STATE OF NORTH CAROLINA
DEPARTMENT OF TRANSPORTATION

Subject: **Modification Request for the Individual Section 404 and Section 10 Permits, Section 401 Water Quality Certification and CAMA Major Development Permit** for the Wilmington Bypass from north of US 74/76 in Brunswick County to US 421 in New Hanover County. Federal Aid Project Nos. NHF-0017 (96) and STM-0017 (97), Division 3, TIP No. R-2633B. Debit \$475 from WBS Element 34491.1.2

PERMIT DRAWING
SHEET 2 OF 73
REVISED: 1/20/2015

PERMIT DRAWING
SHEET 21 OF 73
REVISED: 1/20/2015

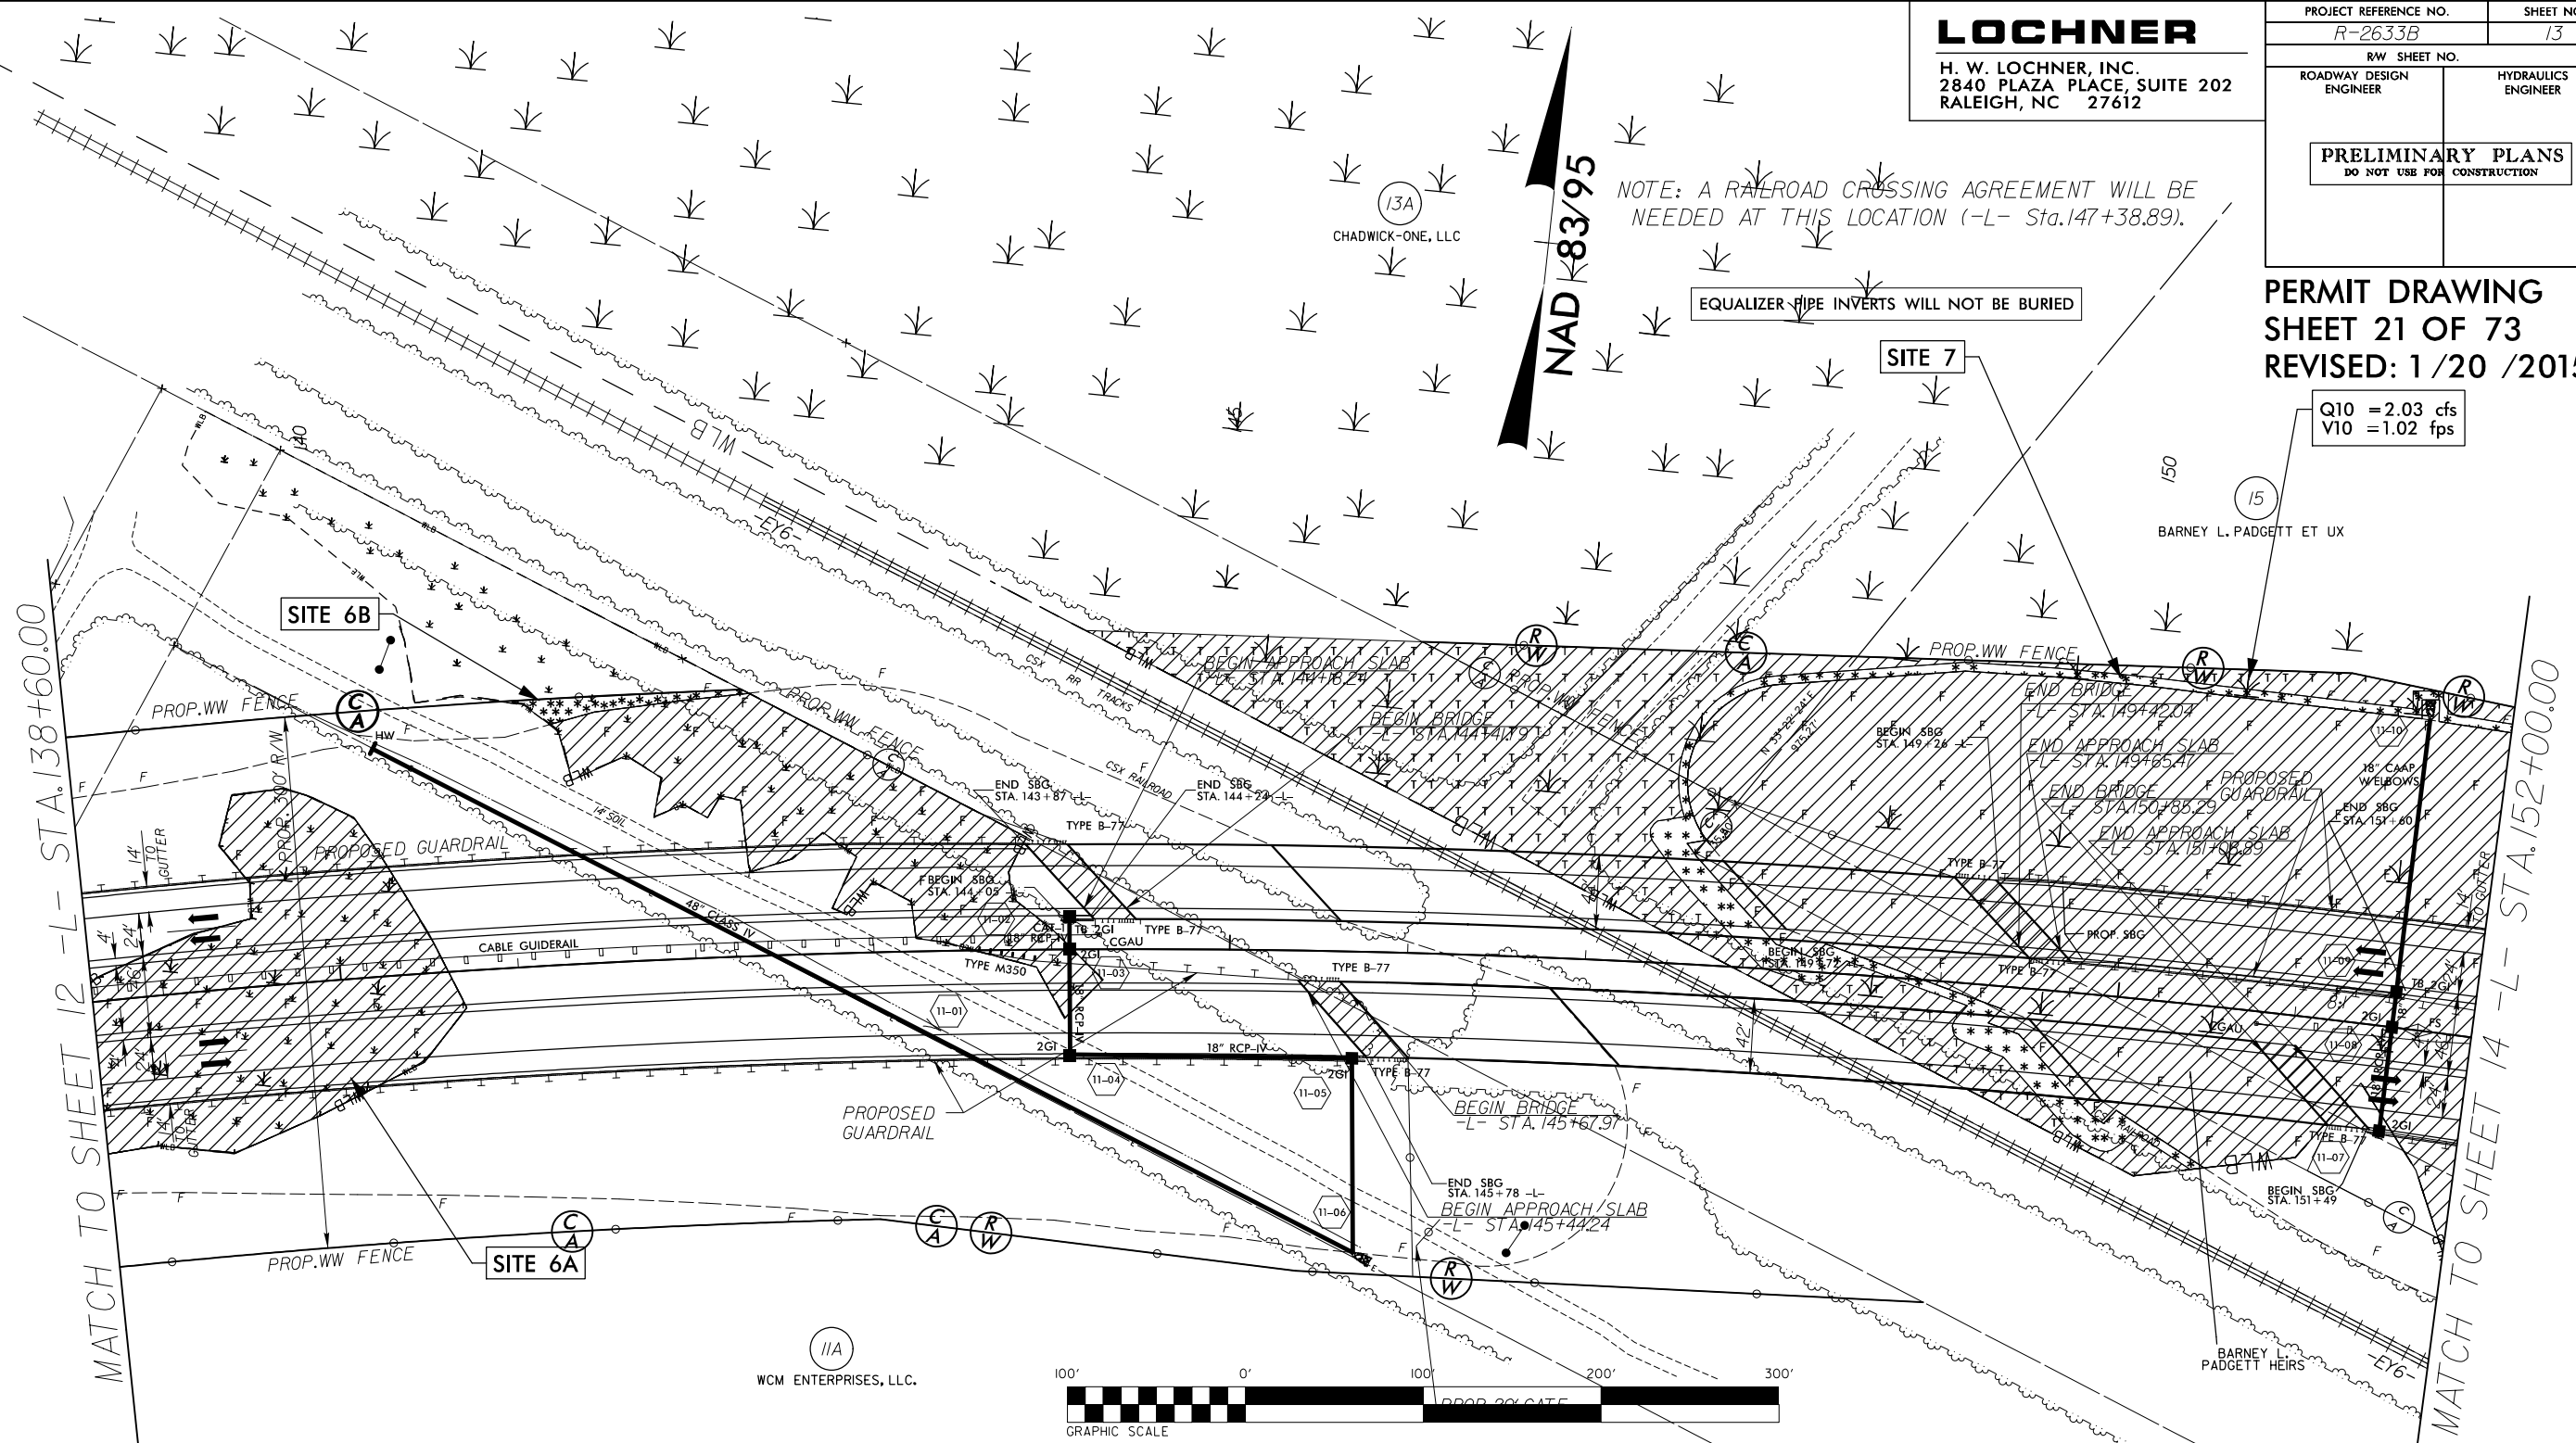
Site 7 was revised to include mechanized clearing and work at the railroad track bridge on Section BA is going to require significant work and storage areas on both sides of the railroad tracks. There is a 256 foot long center span girder of which will have to be spliced together. Also, the NCDOT Geotechnical Unit has advised that the bridge approach fill in this area will have to be placed and allowed to settle prior to the installation of piles for end bents and drilled shafts for interior bents. This means that the contractor will have to operate from existing ground outside of the permanent fill area as the top area of the approach fills would be too high and set too far away from where the piles and drilled shafts need to be installed. NCDOT proposes an area of temporary fill abutting the permanent fill in order to facilitate the necessary staging and working of materials, equipment, and labor in order to properly achieve the bridge construction in this area. The area for temporary fill would be cleared in manner consistent with hand clearing and then fabric would be placed on the existing ground. Approximately 3 feet of soil material would be placed on top of the fabric. Equipment, materials, and personnel would be staged and worked in the temporary fill area in order to construct the bridge. The temporary fill and fabric would be removed and the area would be restored as much as possible to preconstruction conditions at the appropriate time.

Permanent non-riparian wetland impacts at Site 7 will increase by 0.52 acre. Temporary non-riparian wetland impacts will increase by 0.92 acre. Hand clearing will be decreased by 0.56 acre.

PERMIT DRAWING
SHEET 64 OF 73
REVISED: 1 / 20 / 2015

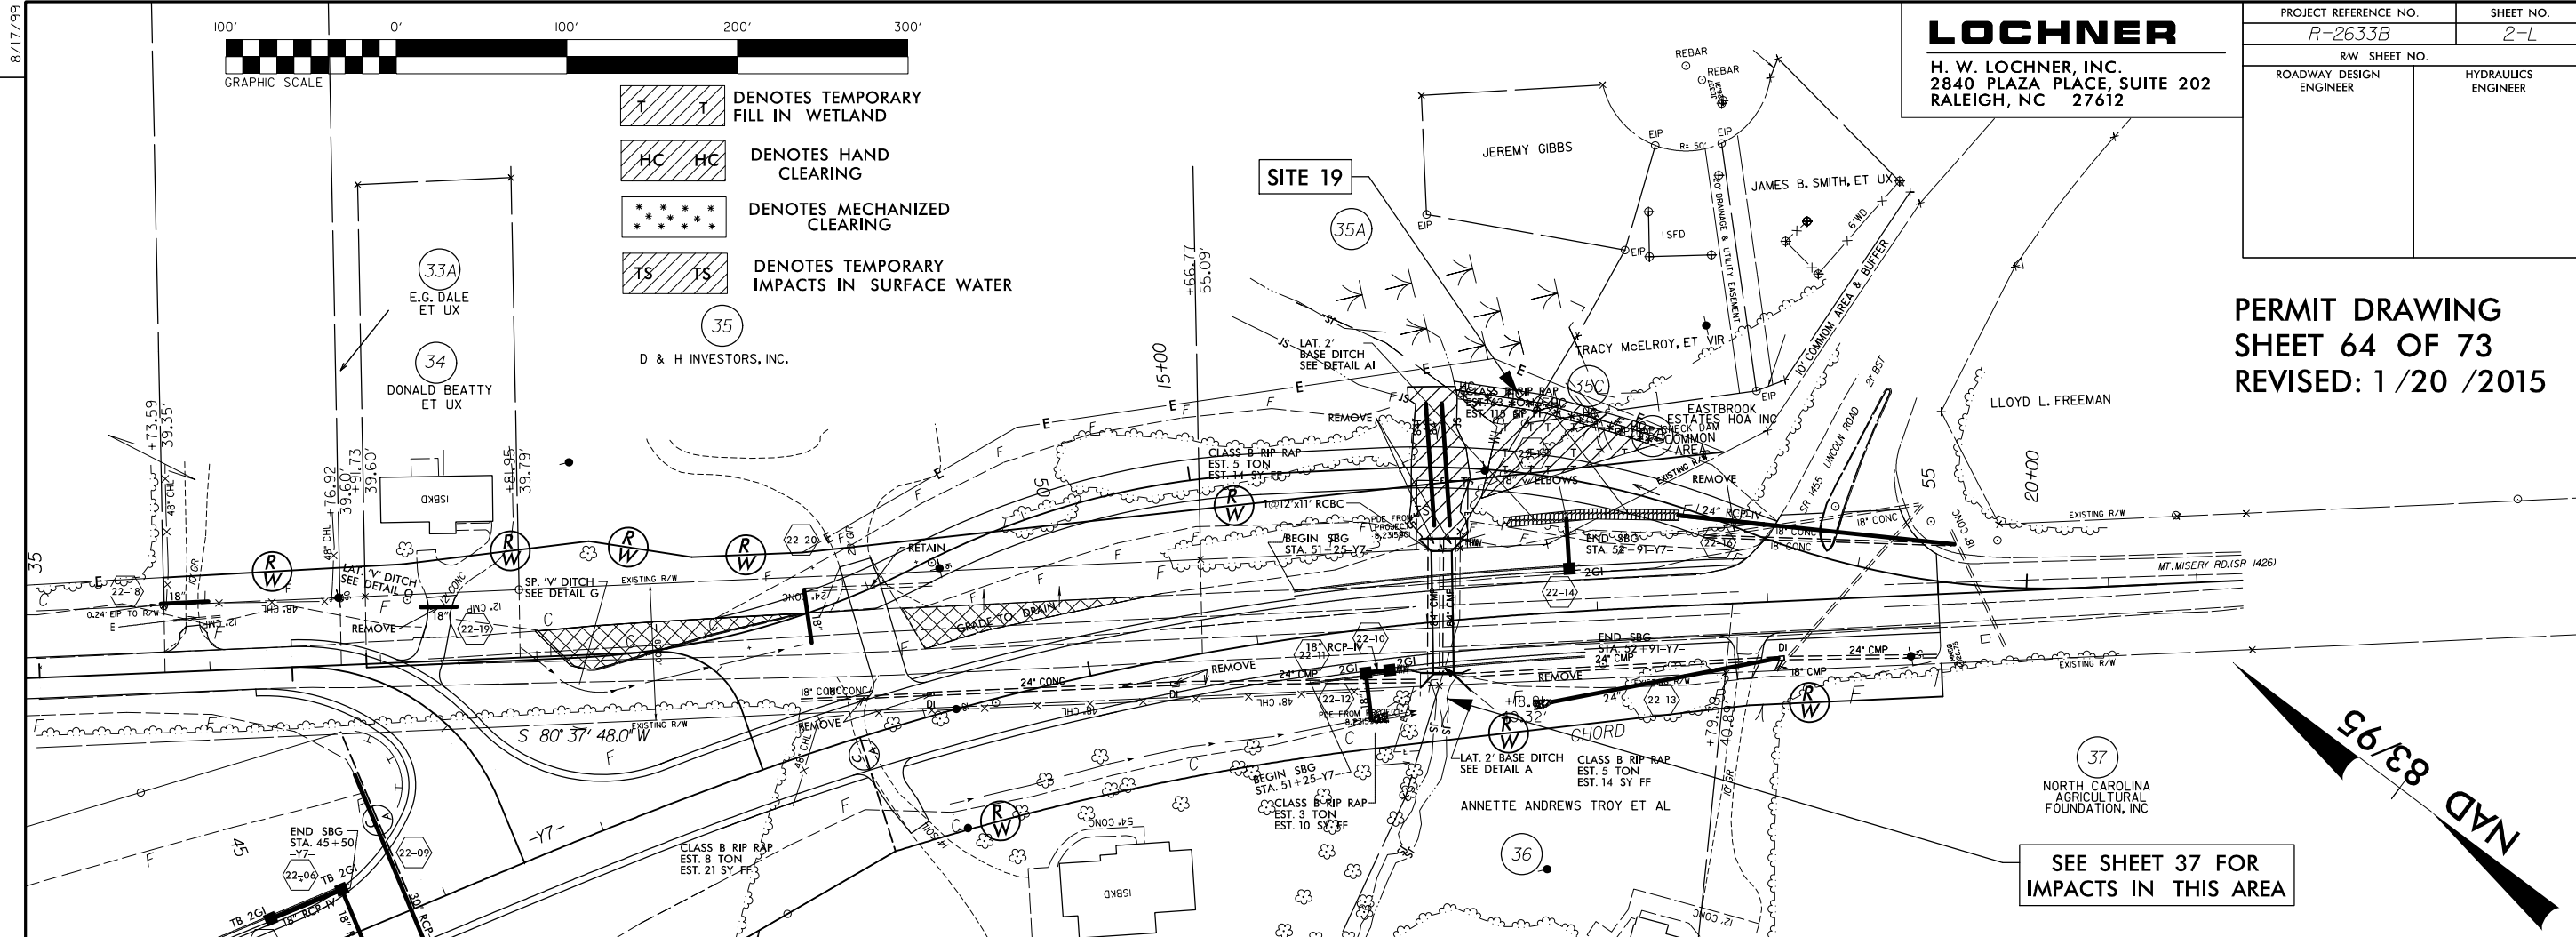
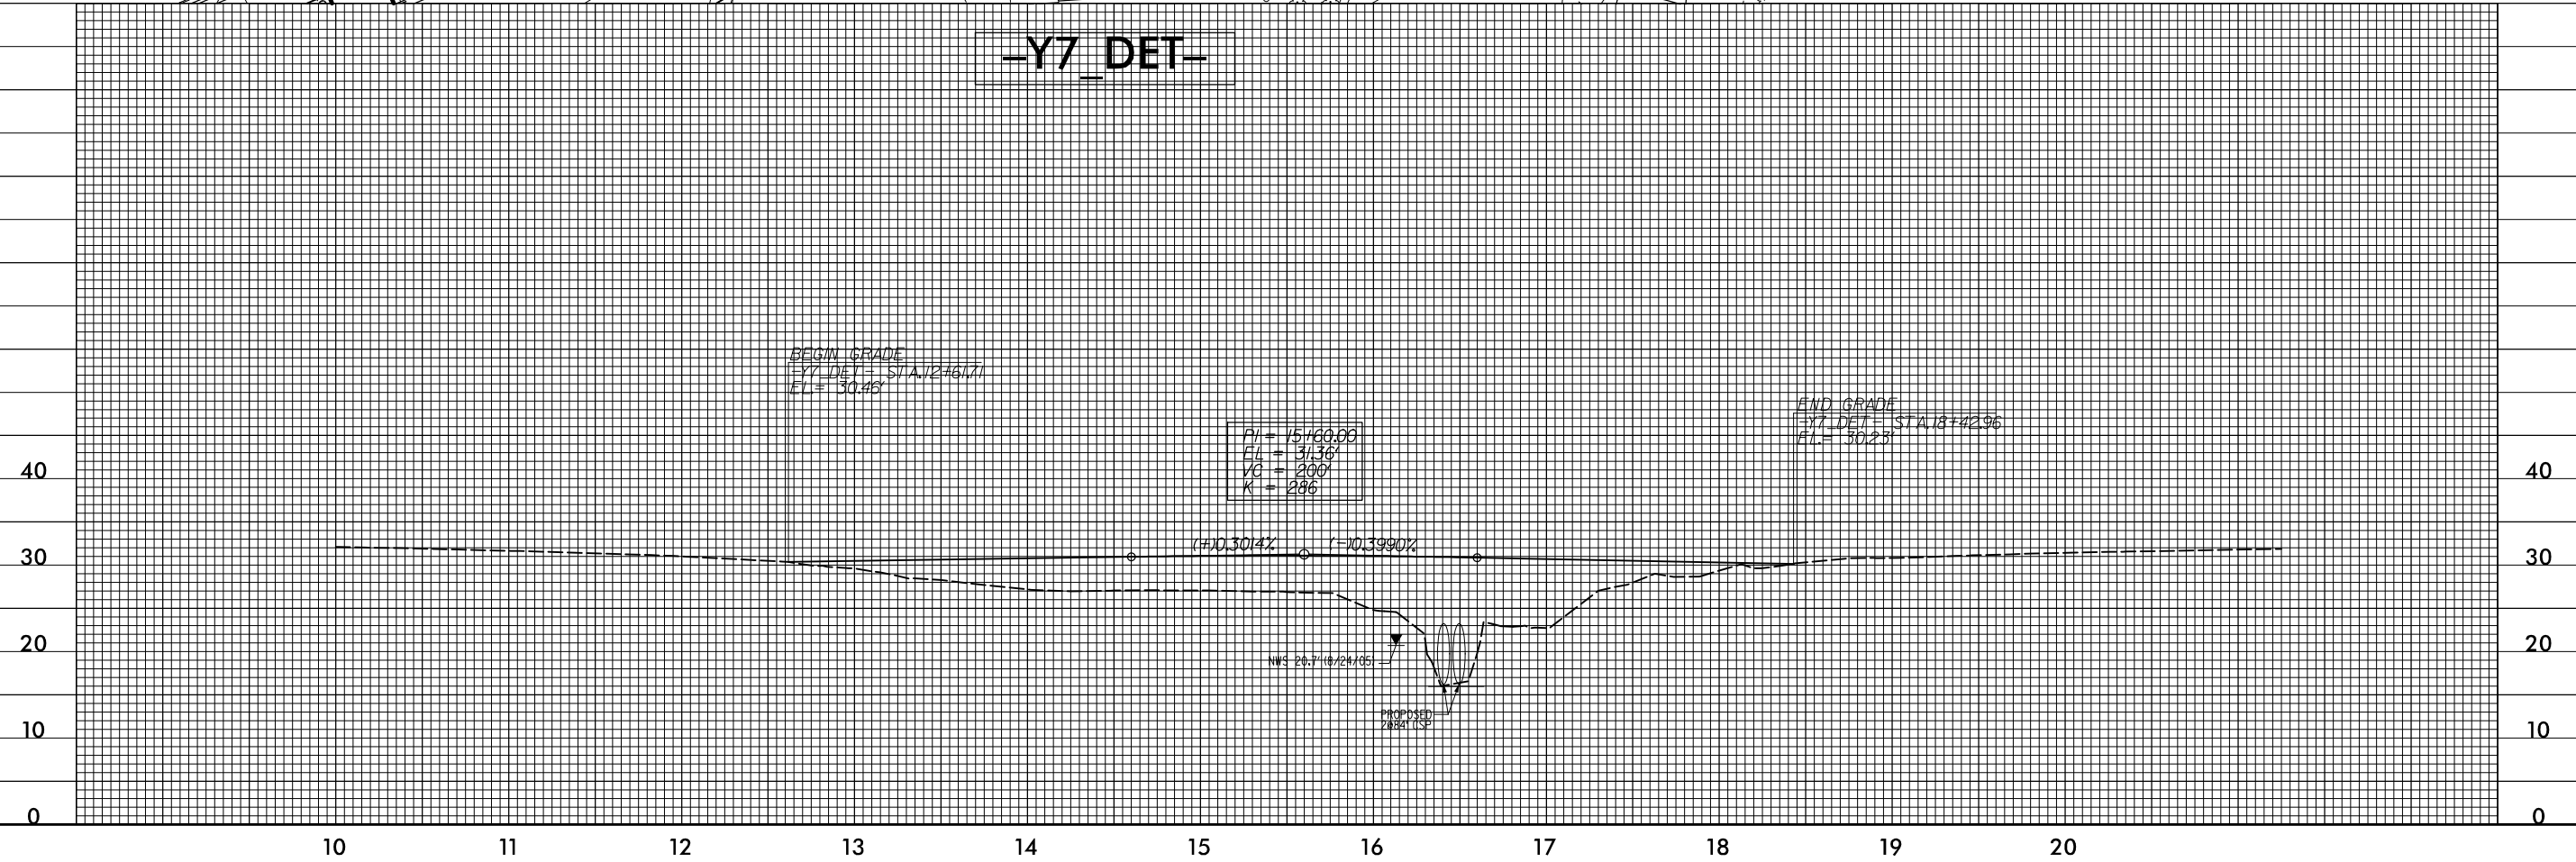
Site 19, detour drawing, Sheet 2L was revised from the original drawing. The original profile on this drawing showed the temporary pipes buried 3 feet. This was later questioned and the consultant collected more recent data. The drawing was changed but the temporary pipes on the profile now appear to be sitting on top of the streambed. See enclosed screen snapshot drawing showing the pipes will be buried one foot. Permit Drawing Sheets 64 and 65 of 73 have been revised and included in this application. No changes have been made to jurisdictional impacts.
